AMENDED PLAN OF ADD & ALT IN BUILDING

OF PLOT N^o 37 SHEET M.R.1.

Case No. P/44 of 1932.

REFERENCE No. L. M. A. B. S. P. 44 OF 1932.

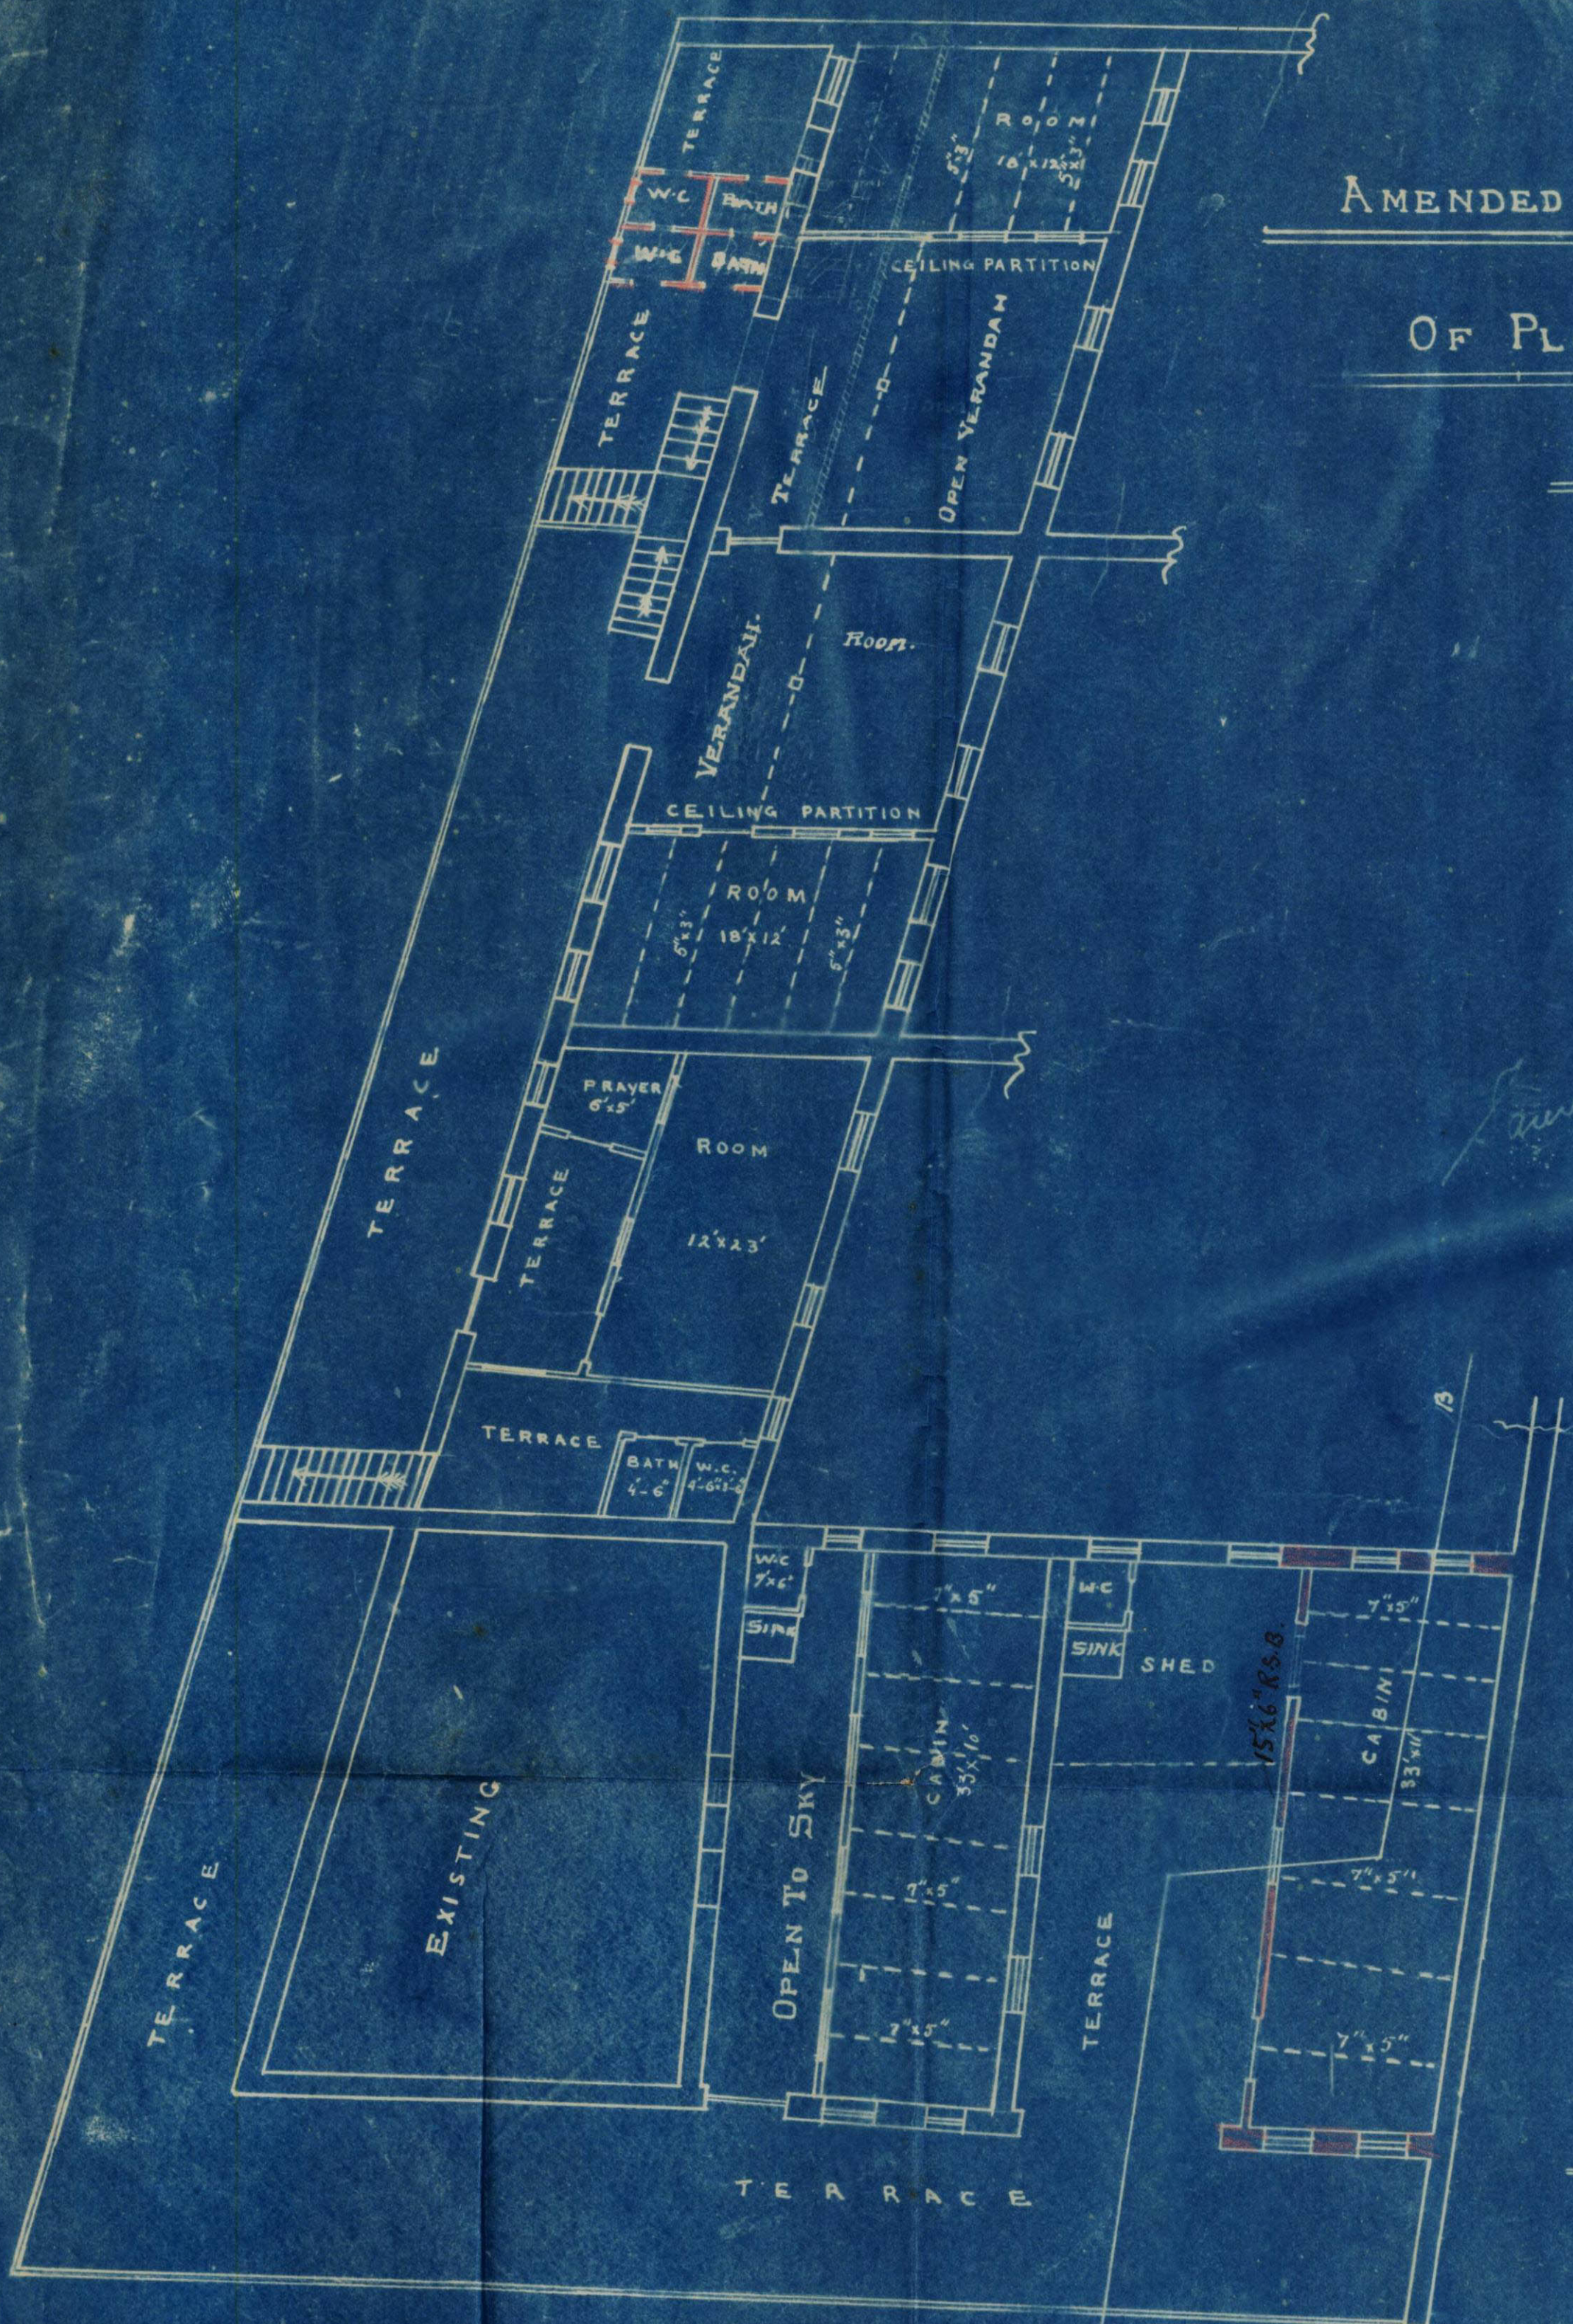
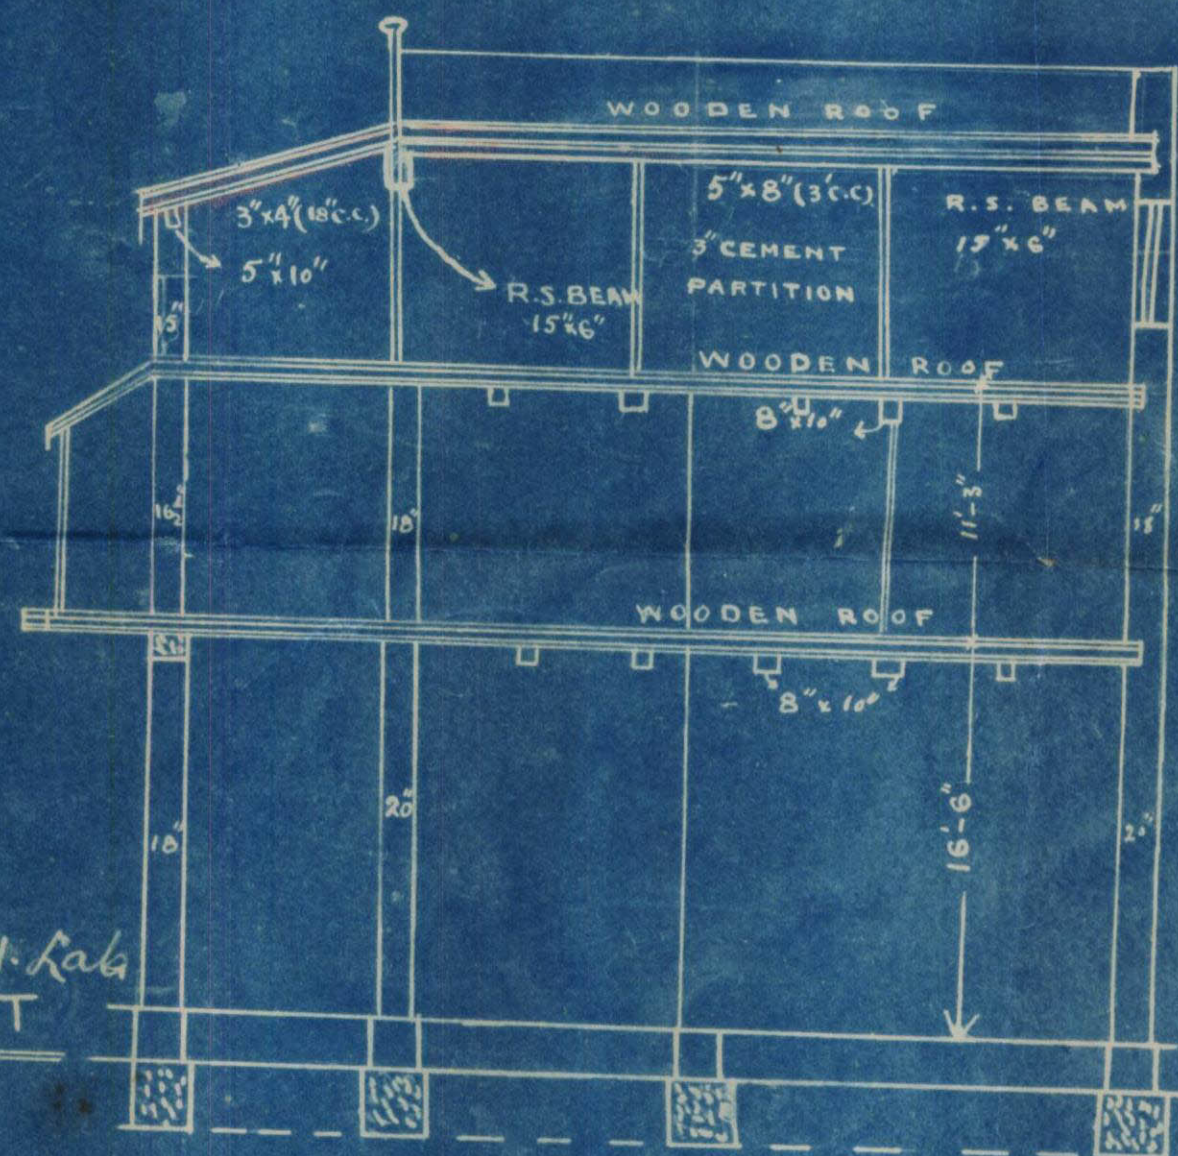
1) W.C. & bathrooms over projecting galleries cannot be allowed.

2) The shed on the 2nd floor, where the cabin is proposed is in dangerous condition and must be removed immediately.

3) 15" x 6" R.C. joister is inadequate for a span of 33'. An intermediate post be provided, resting on foot or wall below.

4) The proposed work must be shown coloured red on all the plans.

5) Cross-section is wrong shown, it must be corrected to the height of the proposed cabin be given.

6) Wooden walls by the side of the stairs must be removed and replaced by walls of non-inflammable materials.

7) Stone steps projecting on the pavement must be removed.

8) Western wall of the cabin be made of cement blocks as above walls cannot be allowed.

- (1) Cell's & bathrooms over projecting galleries cannot be altered.
- (2) Window on 2nd floor where the Calm is proposed is in a dangerous condition & must be removed immediately.

- (3) 15" x 6" R.C. girder is inadequate for a span of 33'. An intermediate post be provided resting on post & wall below.
- (4) The proposed work must be shown coloured red on all the plans.

- (5) Cross section is wrongly shown, it must be corrected & the height of the proposed Calm be given.
- (6) Mason walls by the side of the stairs must be removed & replaced by walls of non-inflammable materials.

- (7) Stair steps projecting on the pavement must be removed.
- (8) Western wall of the Calm be made of cement block & adobe walls.
- (9) The work must be started within the R.C. limit.

- (10) 33' is a big span & R.C. Column in addition if necessary from the very ground floor.
- (11) For new heart foundation must be exposed and interior sent to this office for inspection.

1. Staircase leading to 2nd floor to be made easy by redesigning.
2. In order to allow proper support to 15"x 6" R.S. Girder it is necessary to provide 8"x 8" wooden post. The second floor is without convenience yet it is being used for residential purposes.

- (1) Section of the Sanitary block be given.
- (2) The drainage on Imperial Road be proposed for the road that leading to the area and the proposed to be made more easy as the existing one is very steep.
- (3)
- (4)
- (5)
- (6)
- (7)
- (8)
- (9)

1. W.C & Bath are not on projecting galleries but on terrace. The plan was wrong and this plan was approved by you.
2. 2nd Cabin will have to be removed as new is proposed.
3. 15"x6" is Rolled steel beam & R.C. beam and 6"x6" post is proposed at the centre of the beam from bottom.
4. proposed work is columns red.
5. Cross section is corrected now
6. wooden walls by the side of stair will be covered with gal. sheets. Stone steps will be removed.
7. Western wall will be made of cement block in place of dabra wall
8. All new work will be started after lintol is laid.
9. wooden post 6"x6" is proposed from ground.
10. Plans are already passed by you and approved plan was shown to Building Surveyor under the circumstances foundation should not be exposed.
Please approve the plan. Y. fauzel
- cub

2. Posts 8" x 8" is provided in the ground floor as desired by you, although it is an abnormal size.

3. The second floor is not without any sanitary blocks but there are three sanitary blocks and the health officer would never have passed the plans unless he was satisfied there were sufficient sanitary blocks more ever these are only offices and not residential places.

with reference to your letter
of 16th inst. and with reference to your
interview, I will make the stair
Fire proof from Ground floor to top
floor.

2, top stair will be made easy
